Jeans Plus Ltd. (Extension)

14 October 2024

Factory Building (Extension): 6 storied (G+5) building with a partial basement.

2. Observations

Built-ups

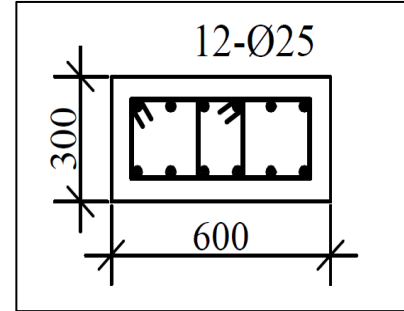
Observation 02: Mismatches/lacking in the as-built drawing (SW size, built-ups, basement layout) (Factory Building- Extension)

Description: Floor built-up was not shown in the load plan, basement & rooftop floor layout not prepared, column size at roof level found 900 mm instead of 600 mm. The building engineer is required to survey the structure and prepare as-built drawings.

4.	Mismatches/lacking in the as-built drawing (SW size, built-ups, basement layout) (Factory Building- Extension)	The building engineer is required to survey the structure and prepare as-built drawings.	within 6 weeks

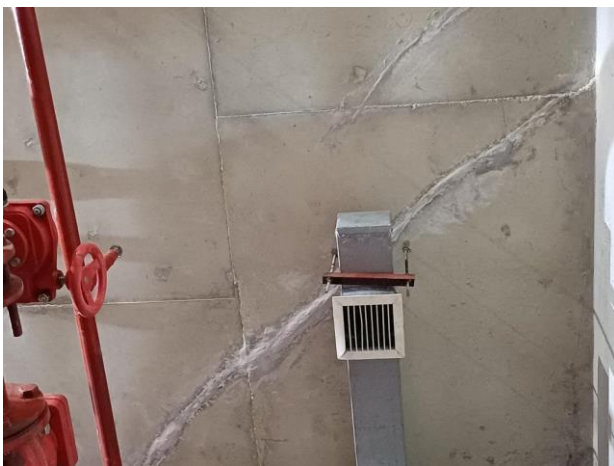
Observation 03: Heavy storage load on the ground floor suspended slabs. (Factory Building-Extension)

Description: During inspection, heavy storage (live load approximately 100 psf/5 kPa) was found on the top slab of UGWR at ground floor, load height marking was missing, and there was no live load plan available onsite. However, reduce storage loading immediately from ground floor suspended area to 3 kPa and maintain until finalization of load plan. Implement allowable load management plan (posting load plan, marking area & load height, maintaining floor load accordingly) after finalization.

5.	Heavy storage load on the ground floor suspended slabs. (Factory Building-Extension)	Reduce loading immediately from ground floor suspended area to 3 kPa and maintain until finalization of allowable floor live load plan.	Immediate
